# Some Comments on Assembly and Performance of pre-series RE2/2 chambers

With input and comments from all colleagues in the ISR lab.  
Additional corrections and tuning by Austin Ball

The 3 Chambers were received at CERN on the 2nd June 2005.

- Signal Cabling

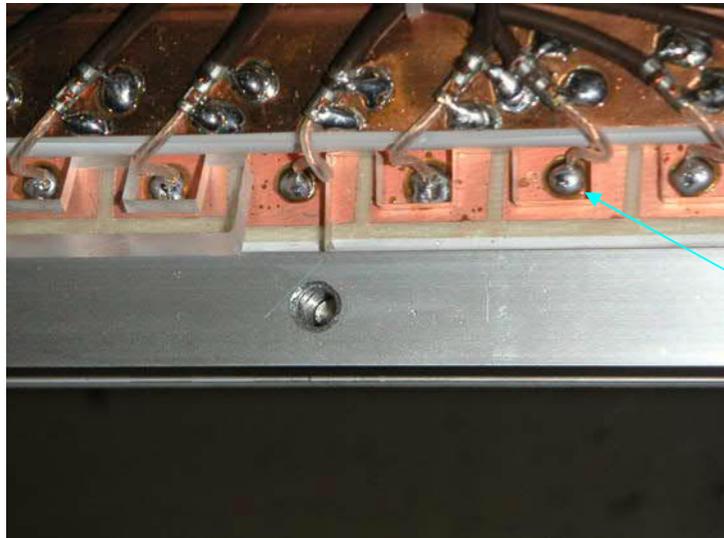
The soldering of the ferrule to the thick copper sheet is done well considering the difficult conditions. Thermal damage to the insulation of the centre conductor is minimal, amazingly.

However the wetting of the surface is not optimal and should improve considerably with the arrival of the Cu from Italy. If additional flux has been used then this should be washed off with acetone and isopropyl alcohol.

The soldering to the strips ( 35 $\mu$ m Cu ) is generally good but there is room for improvement in consistency.

The cut out to access this solder point is a better concept than in RE1

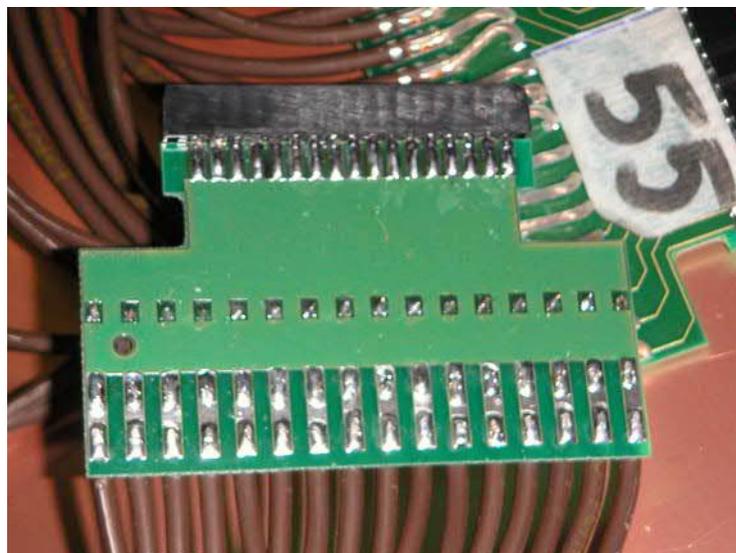
The soldering to the adaptor boards appears well done .

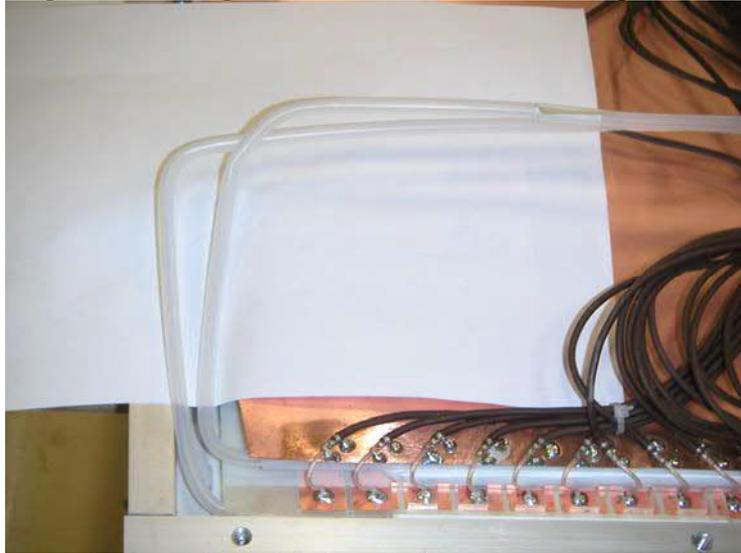
Securing the cables is good as is the orientation of the ferrules upon soldering to the Cu sheet. This angle is most important as it dictates the routing .

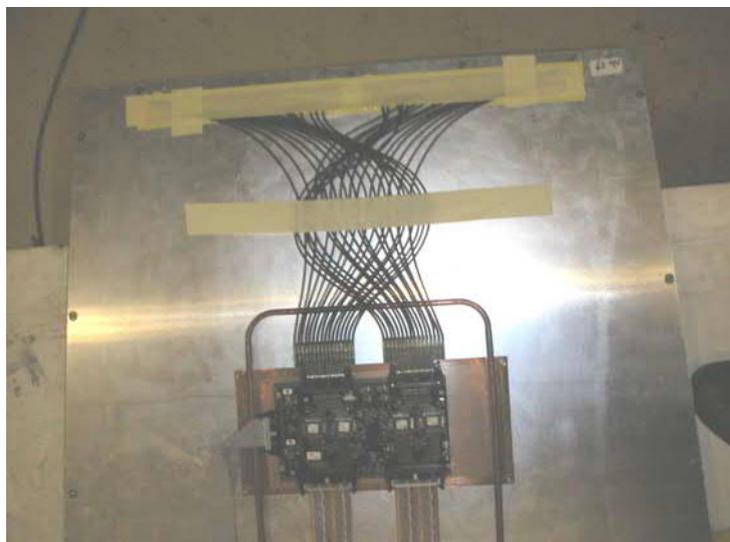
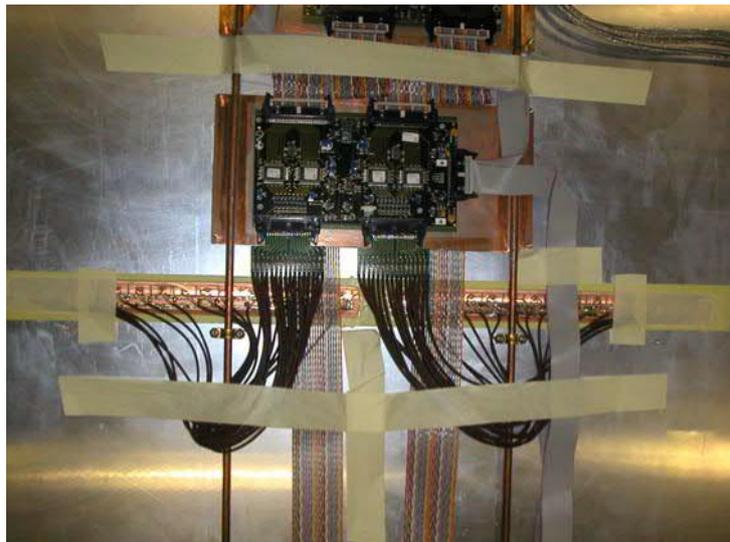
We recommend revisiting the routing to obtain a more repeatable result as illustrated below on these RE1 chambers.

The Mylar film has been cut back as little as possible so that it acts as a protection to the coaxial cables, this is good solution and could be extended to cover both the lower and upper sharp edges of the HCP.( Honey comb Panel). However where the cables must run along inside the channel before exiting, an additional solution is required.

If this solution is retained, then the positioning of the Mylar is critical to avoid modifications being needed later in assembly process (as evidenced by these irregular edges).

- LV

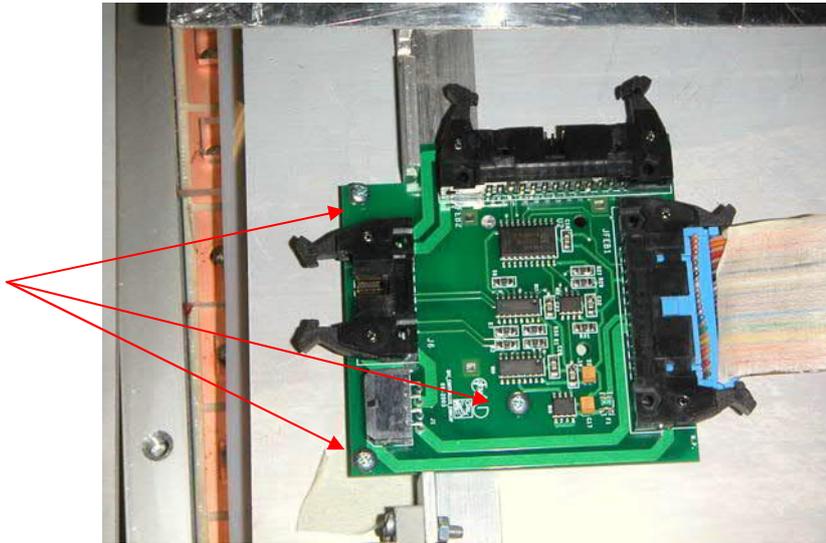
The LV Distribution Board was not fitted to these three pre-series chambers . This should be secured directly to the HCP using small and short (!! ) self tapping screws. A similar solution works extremely well on RE1 for securing the small Alu panels covering the coaxial cables outside the shield box. Here 8mm long PA stand-offs have been envisaged with self tapping screws of 2.9 x 13mm. The lower screw will require an insulating washer as it is very close to a conductor trace.

Little advantage can be obtained by folding the cable at a traditional 90 degrees. Here a slight reduction in length is obtained with a consequent lose in esthetic appeal !

The use of twist and flat cable for the power cables imposes 50cm cutting intervals. A flat untwisted cable is adequate and easier to install as the length is not constrained to discrete values. They should be kept, where possible, away from the signal flat cable.

- Flat cables

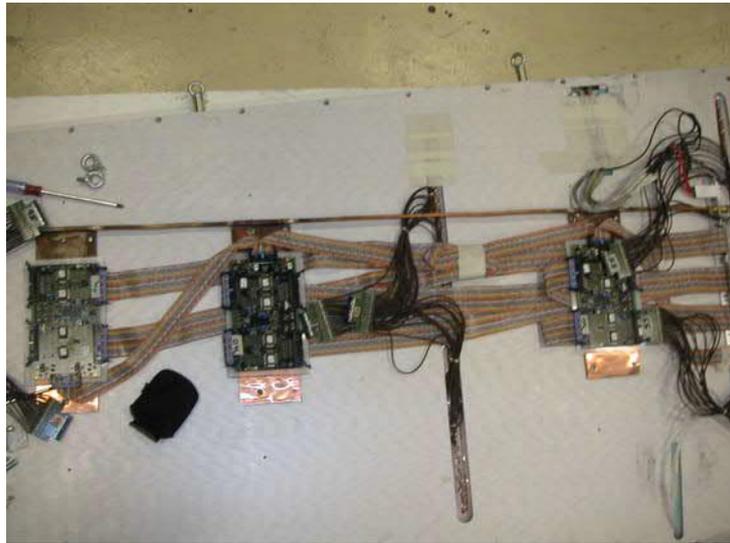
The placement of the FEB can be offset in phi so as to obtain parallel paths for the flat cables with no crossover and little excess length. This is the reason why the Cu cooling plates are so ‘wide’ in phi.

Here the cables run parallel with no crossing and only 2 thicknesses under the Cu cooling plates.

The cables to one FEB must be of the same length. The signal timing compensation to the Link board box is done off the chamber in the ‘skew clear’ cables .

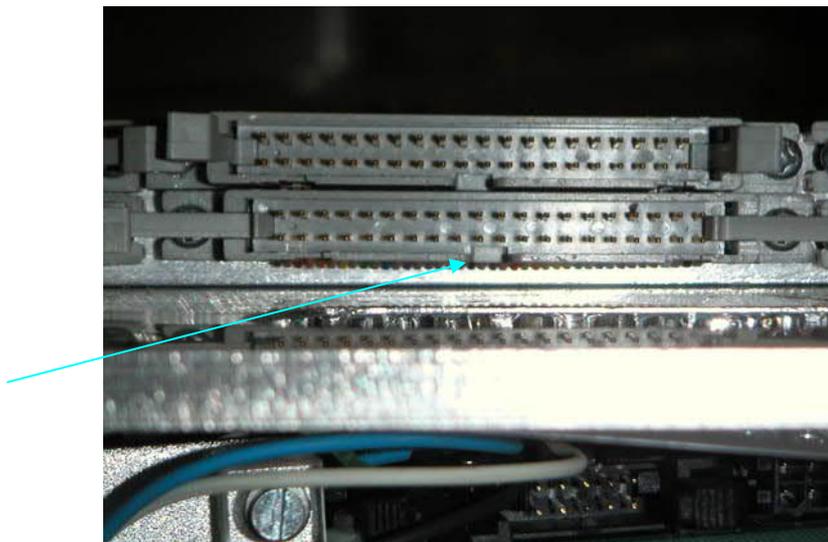
The cable should be cut off flush with the connector as in some cases shorts could occur. Possibly to the HCP or an adjacent connector.

Crimping of the connectors is most important as this will influence reliability and operational life time. Care must be taken and the operation followed closely.

The routing of the flat cables is not trivial and if at all possible must agree with those chambers already made, namely RE1. This is necessary as the read out is entirely dependant upon the cable routing and consequent connector layout on the patch panel.

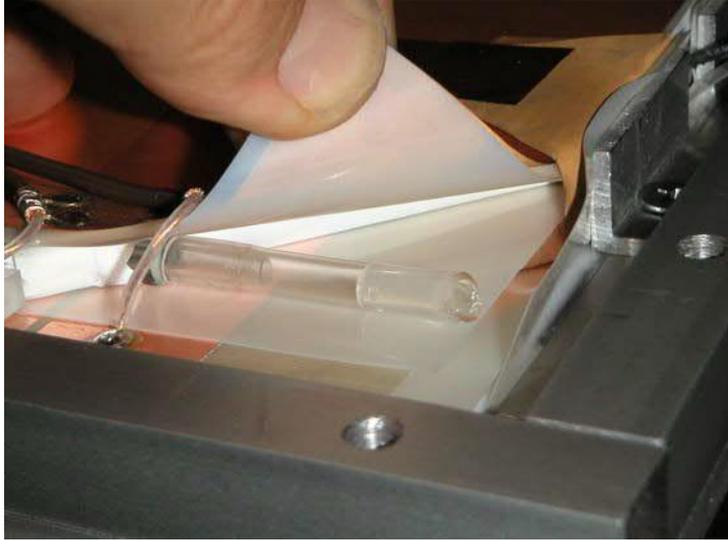
Plugging up of the unused gap connexions should preferably be done with the PE pipe used else where and not PVC. The PVC will resist chemically but may be more liable to hardening in time.

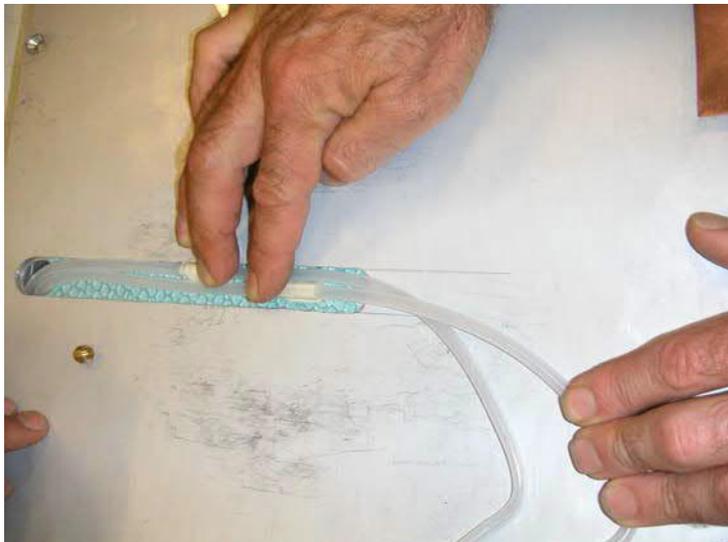
The cut outs in the panel are not deep enough and so leave a rough surface for the pipes to be damaged upon. Taping, remilling or filling with a low viscosity caulking compound should be considered.

The routing and thermo forming of the gas pipes must be done so that the routing is facilitated. This is not such a good example. Numerous iterations will be needed to obtain a good repeatable result. Tooling is essential for each model of pipe.

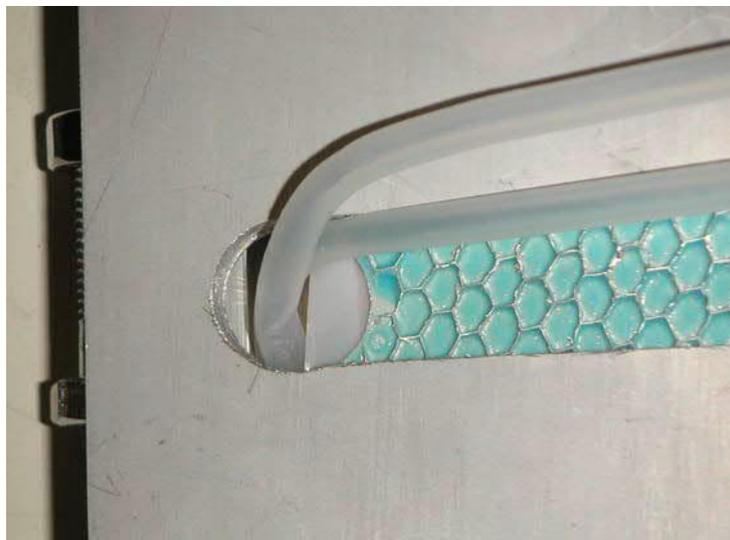
Coming back to cut outs, here the gas pipe can easily be kinked if the hole is too small as is the case in the picture below. (The HV cutout is a good example ). Flow should not be obstructed. The kink will be unlikely to relax and alleviate the problem

The pre-forming of the pipes must be done according to a pre-established method, using standard tooling (to guarantee the right temperature for the correct length of time). In the case illustrated, the pipe has melted and is damaged.

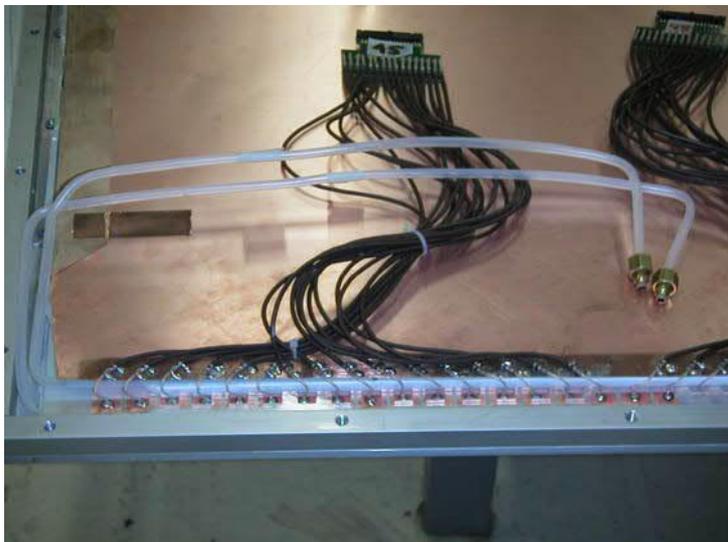
The routing has to be simplified, avoiding unnecessary crossovers

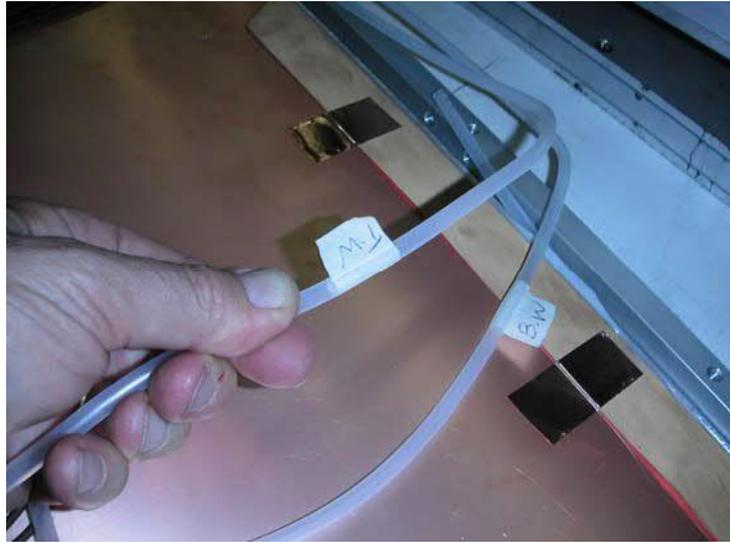
Labeling the pipes is good practice to prevent mistakes.

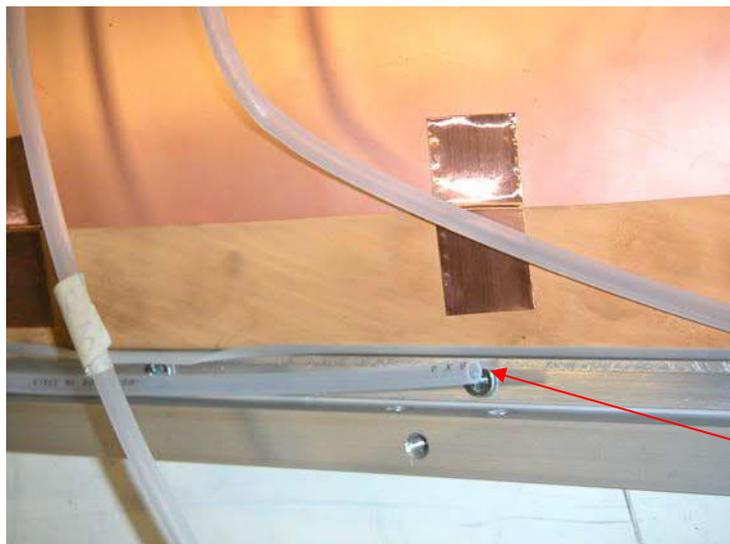
Leaving spare pipe in the chamber is not really useful.

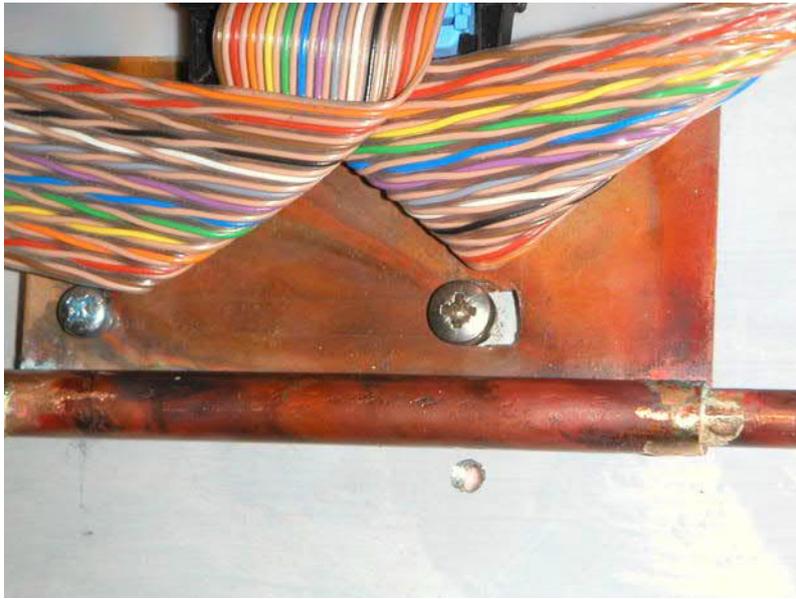
The design of the FEB support plate to 8mm pipe can be simplified by a simple overlay. Sufficient strength will be achieved. The pipe between bulkheads must be a continuous piece to ensure a leak free system. The copper pipe should be hard, not annealed, for reasons of long term leak tightness at the union .

Two M5 inserts have been provided in the HCP for pipe mounting using the clamp shown and an additional one on the far side of the Cu cooling plate. In the RE1 case M6 nuts are used to increase clearance. There seems to be a design error in the RE2 case as one more hole should have been provided on the 'far side', giving a '3 point ' mounting scheme. If hard quality pipe is used, soldered to the cooling plate, the assembly may be rigid enough without modification.

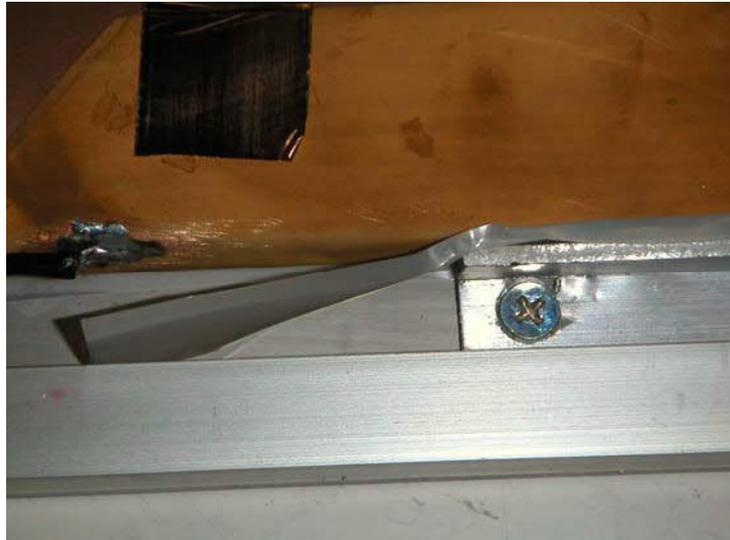
- Space is tight but it all fits ! Perhaps the insulating band on the gap locator could be incorporated into the bottom Mylar layer. In both RE1 and RE2, the gap insulation at the 'R' ends of the structure should be reviewed.

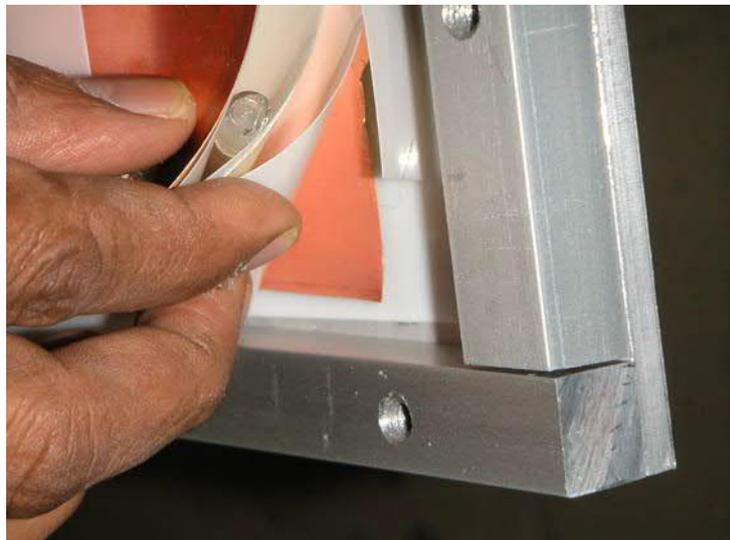
The bottom copper foil must be insulated from the chamber chassis. Since the chambers are vertical the copper film may shift, thus the edges should be insulated with tape. Tape used to retain pieces in place during assembly is insufficient. Some additional positive location is needed.

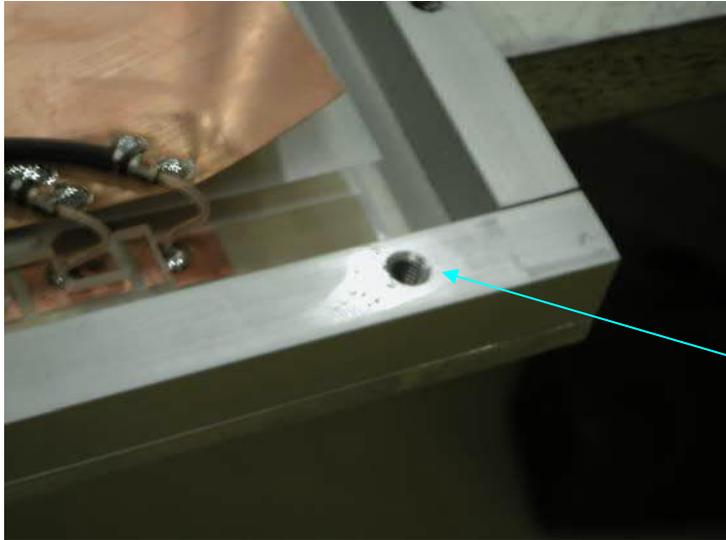
- Overall the structure of the chamber appeared fine but it would be preferable to remove traces of oil.

- More importantly any metallic swarf should be removed as it will tend to move under the influence of the 'E'(and or 'B') fields and finally end up giving a breakdown problem.

- The gaps had been well cleaned as no finger marks were visible.. The gap showed considerable curvature ( $>10\text{mm}$ ).

- The torque of the screws securing the HCPs to the alu. bars ( structure ) should be controlled and tight to ensure the two HCPs work together to form a rigid assembly. Torques of 2-4Nm were measured, where 7-9Nm were expected.

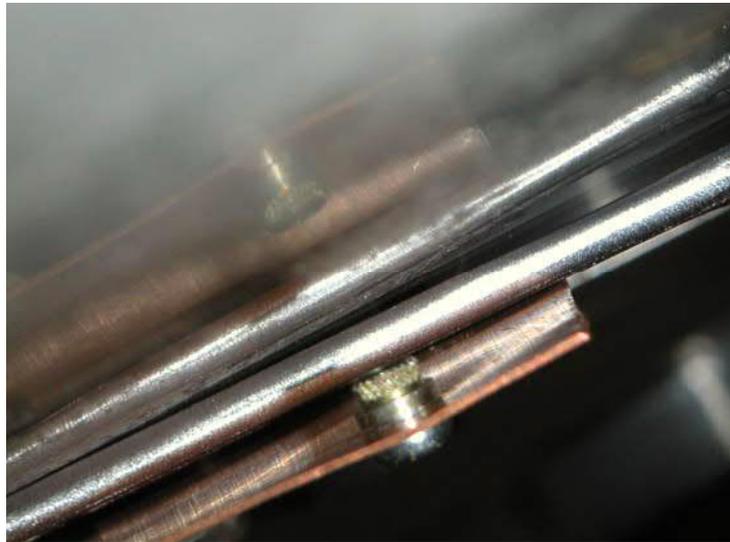
- The FEB should be mounted in a secure manner to the copper cooling system. It is electrically insulated from it.

The spacer necessary should be kept to a minimum so as to keep overall thickness of the chamber to a minimum. This one can be reduced to the thickness of 2 flat cables.

The rigidity of the assembly could be improved .

The very small plastic screws used in attaching the FEB to the cooling plate are fine but insufficient in number (2) and tightness. There must be 3. The holes have to align somewhat better. Mounting the male part to the Cu sheet is a good idea and ensures an easier assembly than in RE1.

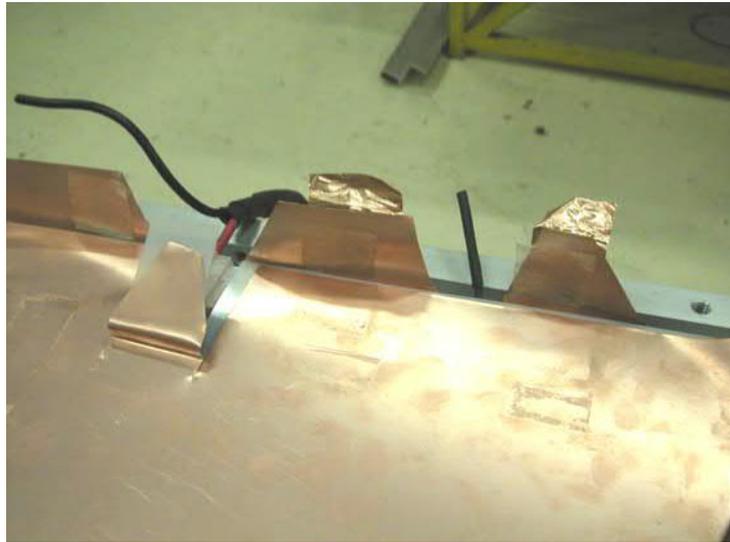
The use of double stick is not sufficient to ensure electrical conductivity in building a Faraday cage but of course it does ensure a close proximity of the two Cu sheets which is also a pre-requisite of same. The tape was tested to be nonconductive.

Soldering of small points along the edge are a good addition to ensure good long term conductivity, once thinner copper sheet is available.

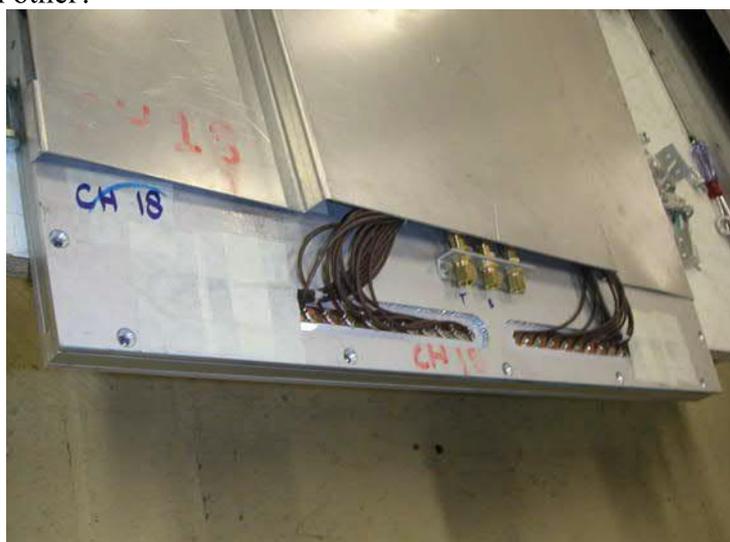
Can the bottom patch panel be reversed so that the cooling and gas pipe do not crossover each other?

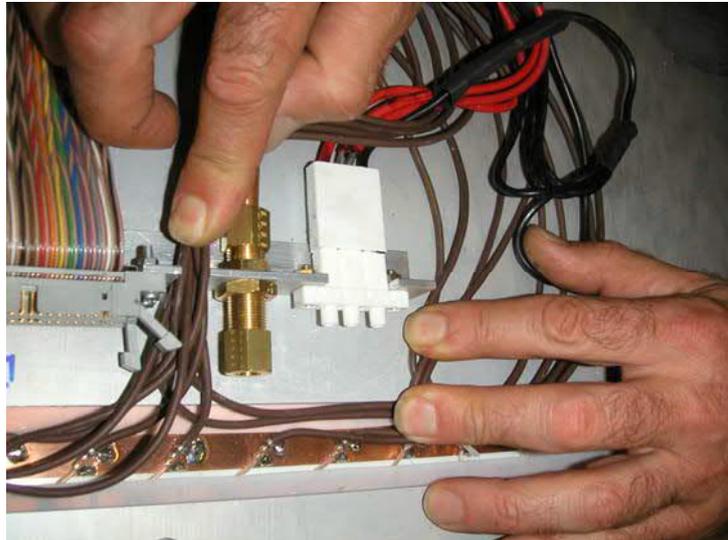
However at the outer 'R' end the situation is more complex. Here the obstruction/hindrane of connectors appears to be a problem. The solution may be to redirect more coaxial cables through the slot already milled next to the cooling union., as shown.
